From: Michael Gray
Sent: 13/01/2023 11:48:08 AM
To: Council Northernbeaches Mailbox
Subject: TRIMMED: DA 2022/2152_122 et al The Avenue Newport - Submission
38 Rednal Street
Attachments: 230112_DA2022_2152_122 The Crescent.pdf;

**RE: DA2022/2152 – 122 et al THE CRESCENT, NEWPORT
SUBMISSION MICHAEL AND MARIAN GRAY – 38 REDNAL STREET, MONA VALE**

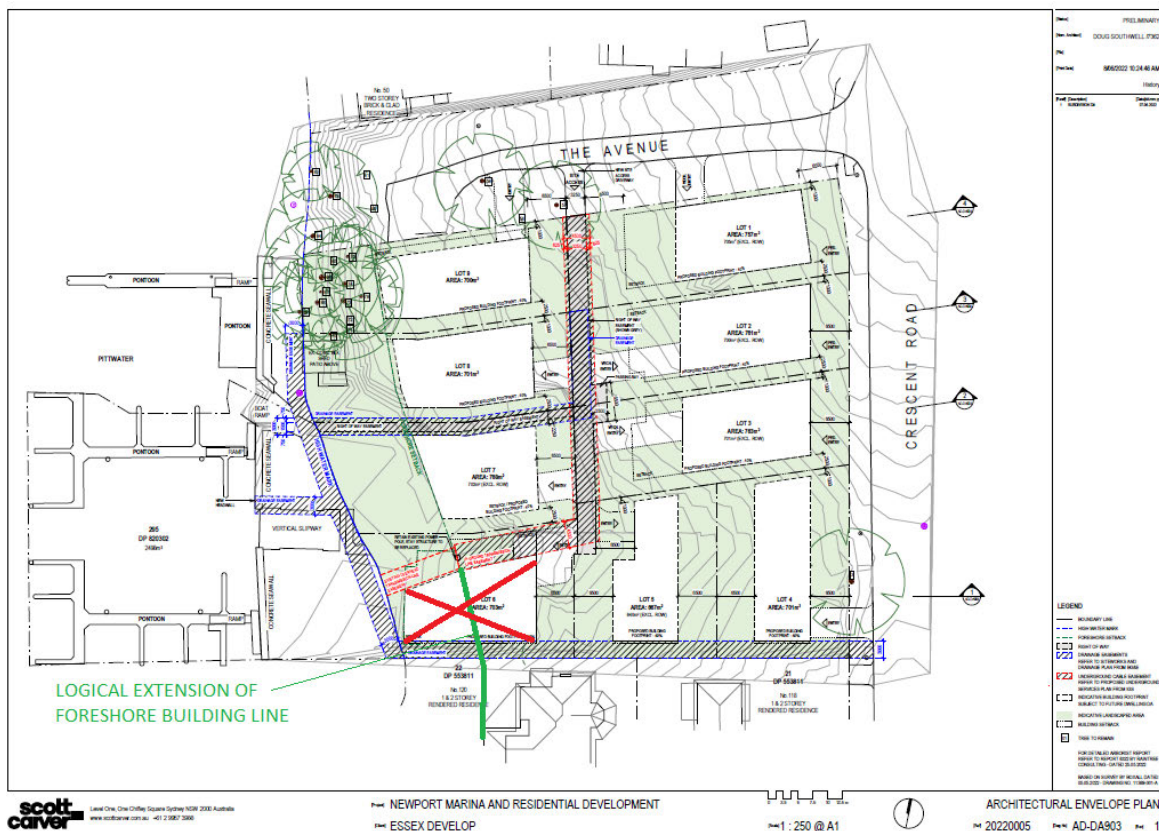
- Item 4.1 Minimum subdivision lots size does not comply – and exemption is sought. In this regard it is noted that the applicant proposes a dwelling well below the logical extension of the foreshore building line and other residences setbacks (refer plan except below)
